**Parks Canada
National Contracting Services**

AMENDMENT #2 TO:

Title-Sujet Reconstruction of Bobs Lake Dam		Date April 10, 2018	
Solicitation No. - No. de l'invitation 5P201-18-0013/A		Client Ref. No. – No. de réf du client. 340	
GETS Reference No. – No de reference de SEAG PW-18-00819112			
Solicitation Closes L'invitation prend fin – at – à 2:00 PM on – le 2018-04-17		Time Zone Fuseau horaire - EDT – Eastern Daylight Time	
F.O.B. - F.A.B. Plant-Usine: <input type="checkbox"/> Destination: <input checked="" type="checkbox"/> Other-Autre: <input type="checkbox"/>			
Address Inquiries to: - Adresser toute demande de renseignements à : Sylvie Lagacé sylvie.lagace@pc.gc.ca			
Telephone No. - No de téléphone 418-648-5006		Fax No. – No de FAX: 418-649-6971	
Destination of Goods, Services, and Construction: Destinations des biens, services et construction: See herein			
Vendor/Firm Name and Address Raison sociale et adresse du fournisseur/de l'entrepreneur Telephone No. - No de téléphone: _____ Facsimile No. - N° de télécopieur: _____

AMENDMENT #2

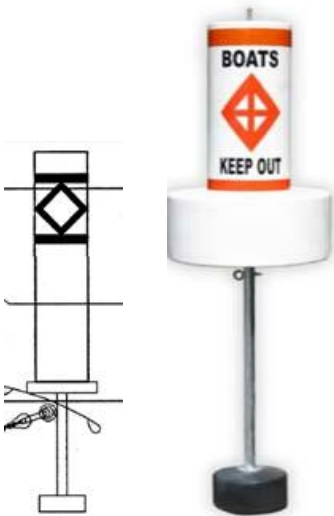
Q.5 We just had a few questions for you. We noticed that Park Canada has the chain going to the anchor with non-galvanized chain. This is not a common thing we have seen. There is also this part underneath the buoy (see image below) that we are not familiar with do you happen to have a part name, or any idea or further details of what it is?

I have a concern that the can buoy shown in the drawing will become submerged due the weight of the anchor chain. I would strongly suggest that the anchor chain connect directly to the TUFFBOOM and that the can buoy is connected to the TUFFBOOM by way of a short chain approximately 2-3ft. See the attached drawing for reference. By the way would you see if Parks Canada would entertain the idea of a float collar can buoy with a ballast instead of the can buoy shown in the drawing. Attached is the idea that we are going for. Please let me know if you have questions.

A.5 Contractors should base their bid for the safety boom and associated components on what is presented in the drawings and specifications. Any adjustments will be administered through the shop drawing and submittal process.
